## **BAMX Comments on the CAISO 2013-14 Transmission Plan: Policy Driven and Economic Assessment**

**Figure 1: Estimated Economic Benefits of the Two Economic Study Projects Under Multiple CAISO Findings**

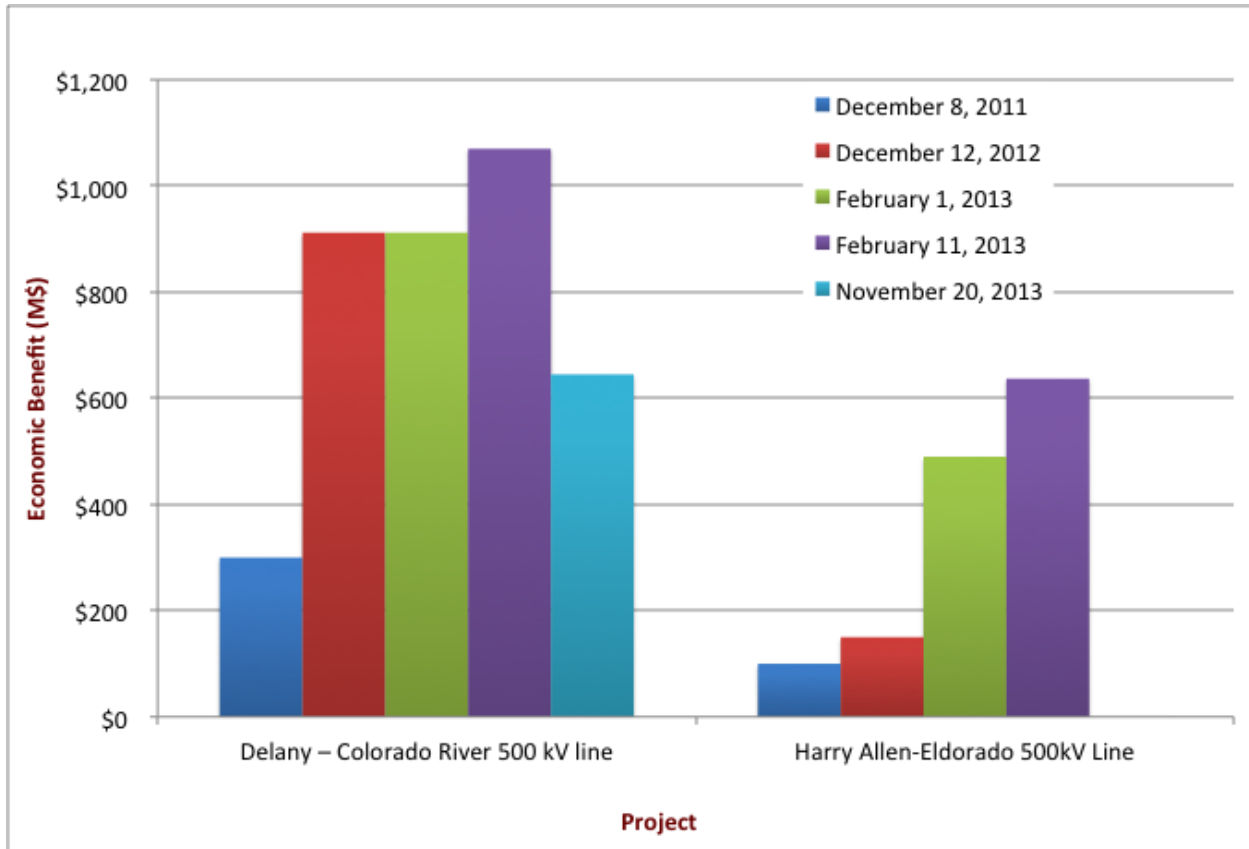
We have noticed that the estimated benefits associated with two candidate projects; the *Delaney – Colorado River (DCR) 500 kV* line project and the *Harry Allen – Eldorado (HAE) 500 kV* line

project have changed significantly under multiple CAISO reportings as shown in Figure 1 below. The CAISO has provided little documentation on the reasons for such major changes in the estimated benefits associated with these transmission projects. We request that the CAISO provide a synopsis of the differences including assumptions and underlying rationale for each finding as well as arguments, if any, as to why the preliminary benefits calculations that were presented in the November 20<sup>th</sup> stakeholder meetings are now sufficiently reliable to support approval of transmission projects costing hundreds of millions of dollars.
